# Access Compliance Report

## Public Rights-of-Way

Intersection ID: 13149	Main Street: CENTRAL_AV	Cross Street: THE_PLAZA	Location: NW
ADA ID: 10CF3654956E	Ramp Type: Perp	Initial Pass/Fail: Fail	Overall Compliance: No
Severity Score: 8.75			
Codes/Mitigation Info/Possible Solution		Field Measurements/Component Compliance

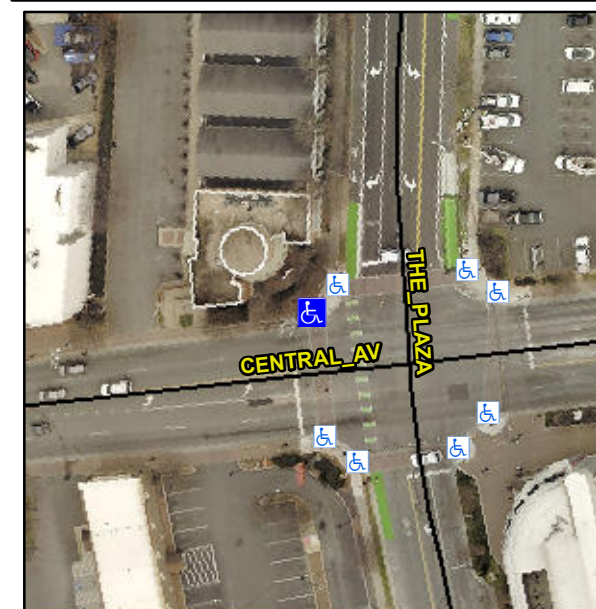
**Not Found, R304.5.1**

Compliance	Description	Data	Compliance	Description	Data
N/A	Ramp Length (in)	74.0	Yes	Ramp Slope (%)	8.0
No	Ramp Width (in)	37.5	Yes	Ramp XSlope (%)	1.0
N/A	Flare Type LT	N/A	N/A	Flare Type RT	N/A
N/A	Flare Slope LT (%)	N/A	N/A	Flare Slope RT (%)	N/A
N/A	Flare Traversable LT?	N/A	N/A	Flare Traversable RT?	N/A
N/A	Landing Length (in)	N/A	N/A	DWS Provided?	N/A
N/A	Landing Width (in)	N/A	N/A	DWS Contrast?	N/A
N/A	Landing Slope (%)	N/A	N/A	DWS Length (in)	N/A
N/A	Landing X Slope (%)	N/A	N/A	DWS Full Width?	N/A
N/A	Landing Curb? (Y/N)	N/A	N/A	DWS Offset (in)	N/A
N/A	Shared Landing?	N/A			
N/A	Gutter Ponding?	N/A	N/A	Gutter Slope (%)	N/A
N/A	Gutter Lip Ht (in)	N/A	N/A	Gutter X Slope (%)	N/A
N/A	Painted X Walk1?	Yes	N/A	Painted X Walk2?	N/A
	X Walk 1 Direction	To S		X Walk 2 Direction	N/A
N/A	X Walk 1 Width (in)	96.0	N/A	X Walk 2 Width (in)	N/A
	X Walk 1 Slope (%)	0.1		X Walk 2 Slope (%)	N/A
	X Walk 1 X Slope (%)	3.4		X Walk 2 X Slope (%)	N/A

**Remove & Replace Entire Ramp.**
